DUKE POWER COMPANY  
OCONEE NUCLEAR STATION  
ATTACHMENT 1  
TECHNICAL SPECIFICATIONS

TECHNICAL SPECIFICATIONS  
MARKED UP COPY

TECHNICAL JUSTIFICATION

Technical Specification Change

OCONEE NUCLEAR STATION  
Figure 3.1.10 - 1

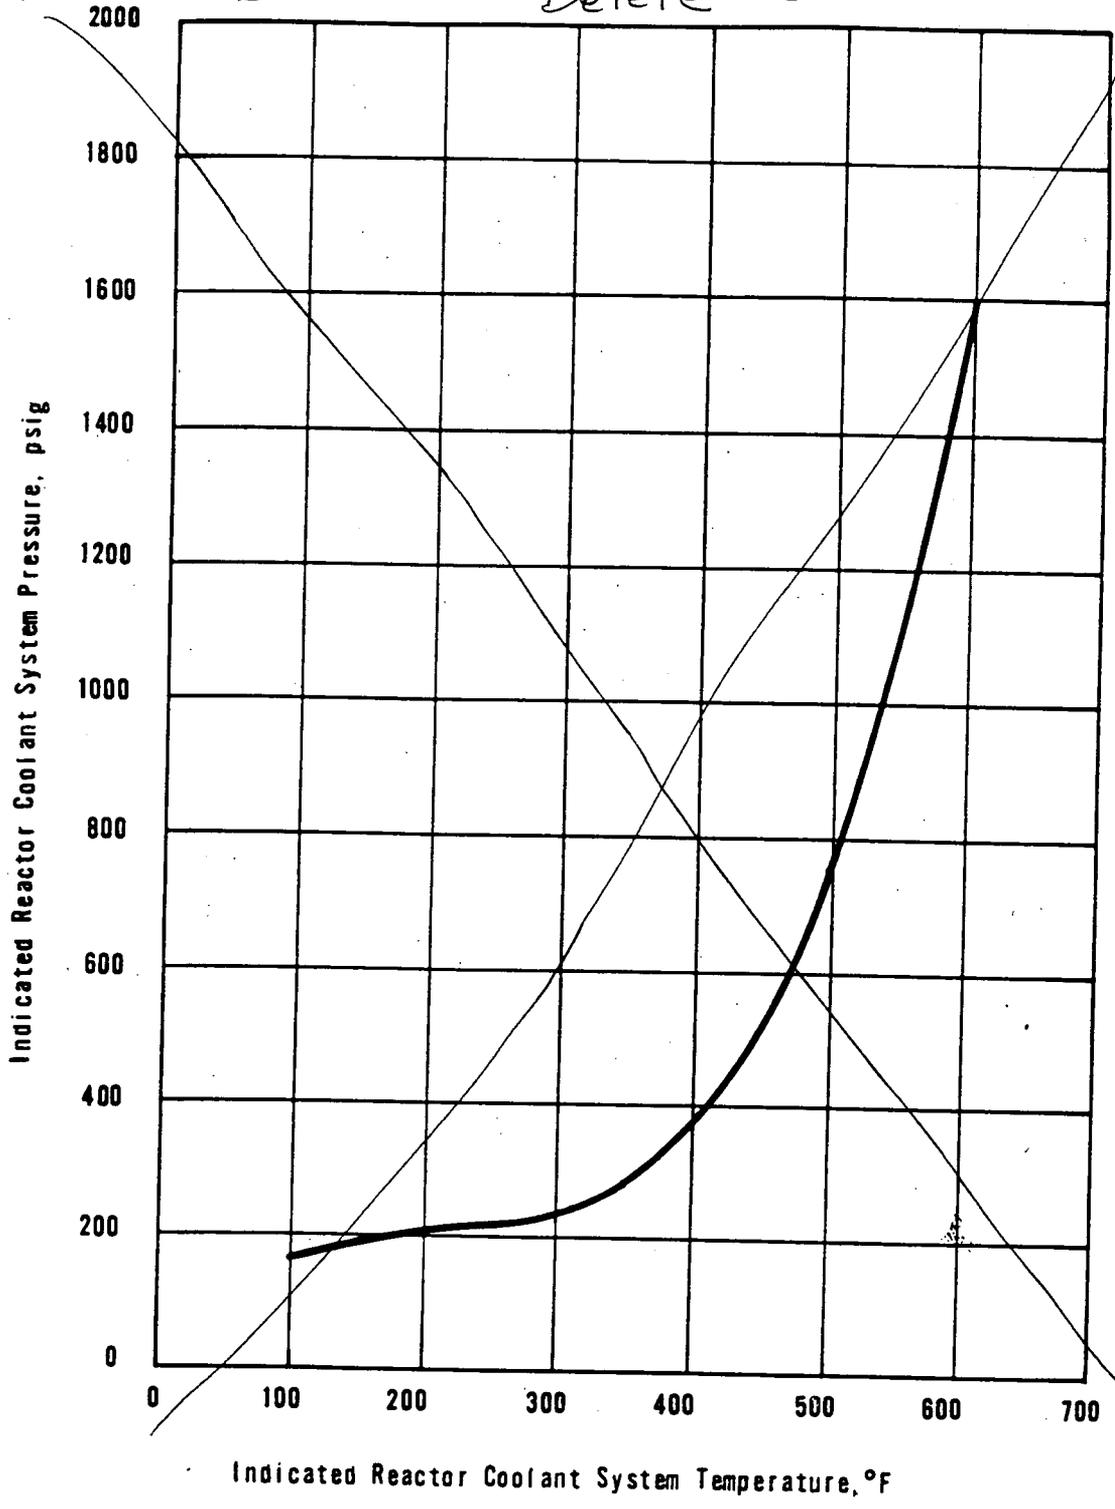
- 3.1.10.1 Allowable combinations of pressure and temperature for control rod operation shall be to the left of and above the limiting pressure versus temperature curve as shown in Figure 3.1.10-1.
- 3.1.10.2 The dissolved gas concentration shall not exceed 100 standard cc/liter.
- 3.1.10.3 If either the limits of 3.1.10.1 or 3.1.10.2 are exceeded, the center control rod drive mechanism shall be checked for accumulation of undissolved gases.

If either the maximum dissolved gas concentration (100 std. cc/liter of water) is exceeded or the operating pressure falls below or to the right of the limiting pressure versus temperature curve, the center CRDM should be checked for accumulation of undissolved gases.

Delete

The elimination of Technical Specification Section 3.1.10 on the dissolved gas concentration in the RCS will not impair the protection of the public health and safety. Monitoring instrumentation, OAC parameters, and operational procedures are in place to ensure that a potential gas-out problem does not occur. In addition, the elimination of this requirement will result in a cost savings to ONS.
